DELEGATED PLANNING APPLICATION REPORT

Application number:	TP-2018-449
Applicant:	Ambertree VIC Mel (Lincoln) Pty Ltd
Address:	23-31 Lincoln Square South, Carlton
Proposal:	Partial demolition and buildings and works including the construction of a multi storey development for use as dwellings and retail (other than Adult sex bookshop, Hotel and Tavern)
Date of application:	1 June 2018
Responsible officer:	Richard Cherry

Figure 9: West Elevation of VCAT Plans (TP-2015-440) – red line indicates general building outline

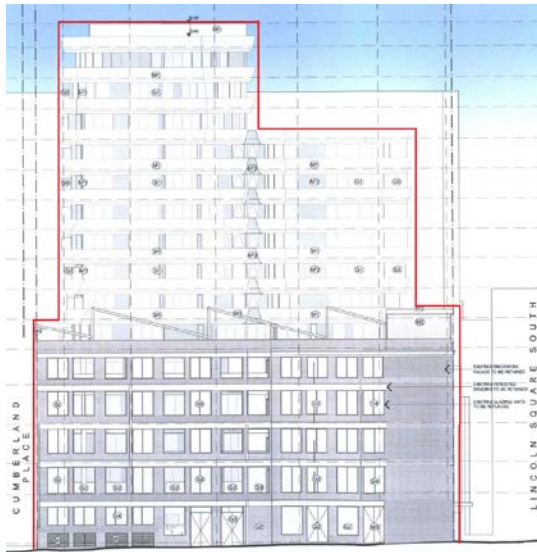
Prior to the Hearing, the permit applicant formally amended the plans, resulting in a building with a total height of 12 storeys (40m) towards the front of the site and 15 storeys (52.75m) towards the rear – see Figure 9.

The taller built form in the rear part (or what we have described as the third part) of the building that is 11.5 m above the preferred maximum building height fails to make an adequate distinction from the taller form in the Hoddle Grid and fails to respect the character of the Square. This is apparent from Mr Choong's photomontages and our inspections. Photomontages V01, V02 and V03 from different points in the Square along Swanston Street show an uncomfortable scale adjoining the Square and a screening of (rather than a transition to) taller form in the Hoddle Grid. The uncomfortable scale is heightened by the rising topography of the Square.

Figure 1. View from Lincoln Square (2015 M Gould)

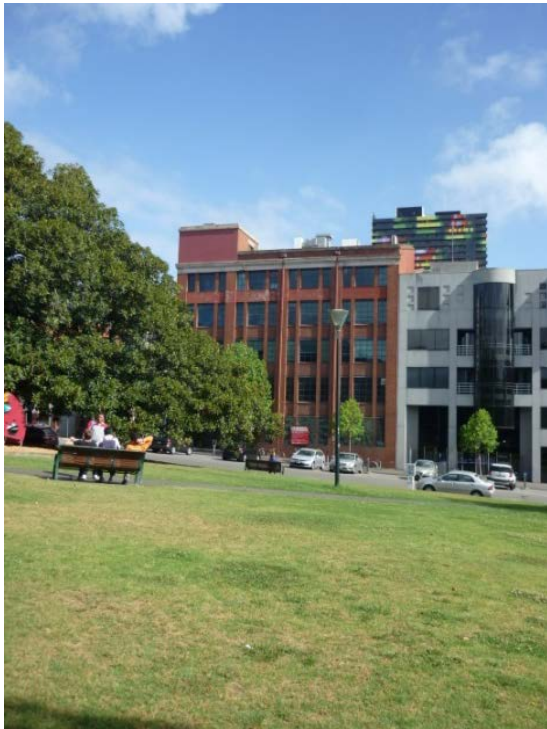
The existing building has prominence in the streetscape when viewed from opposite the site. (Figure 1) Site Section 1 indicates a viewing point within the park (a little east of the view in Figure 1), approximately 70m. from the site.

The tower at RL 78.74 to the top of the articulated screen façade is proposed to have a height of 48.965 metres, rising 28.45 metres above the existing street wall. However the tower height which is perceived by the viewer will be modified by its setback - proposed here at 6.8 metres. At the Site Section 1 viewpoint, the perceived height of the tower will be approximately 117%. It would be perceived to be taller than the street wall height of the existing heritage building and would be a dominant bulk form.

Figure 6. 1927 Original Drawings. From HIS page 7

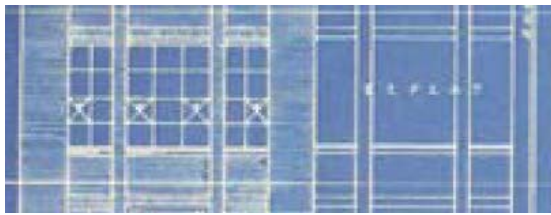
- *The steel framed windows. The description of works to the steel framed windows does not indicate conservation works or clearly indicate retention. Removal of the majority of glazed panels as proposed would increase the exposure of the steel frames to the weather and is likely to reduce the life of this building fabric. Providing reflectance, a balance of light and shade at the openings and strong sense of the enclosure inherent in a warehouse function, the glazed steel framed windows are a distinctive and integral part of the architectural form and contribute to significance. The perception of the original façade design would be changed by the removal of glazing. All three options proposed by the applicant would substantially modify fabric which contributes to significance.*

There would appear to be alternatives. The original windows contain opening sashes. (Figures 6, 7 and 8). Some modification to increase the number of sashes within the existing frames would be supported.

- Retain original clear glass where possible.*
- Locate hopper opening sashes within the single “square” panes of the existing frames, broadly in the locations shown on the 1927 elevation. An increase in the number of hopper sashes would be acceptable, e.g. a full row in the upper band. And at the second band above sill level, modification of the hoppers to open 180 degrees would be supported. This arrangement would provide good air flow in summer, and provide for an open to air connection at person level.*

- e) Further detail of all conservation works to the exterior, including existing steel framed windows and hidden painted signs.
- f) Where additional openable panels are required to existing glazed windows on the north elevation, adopt hopper sashes consistent with the original where appropriate. The capacity to fully close the windows is to be retained on the north elevation unless otherwise agreed by the Responsible Authority.
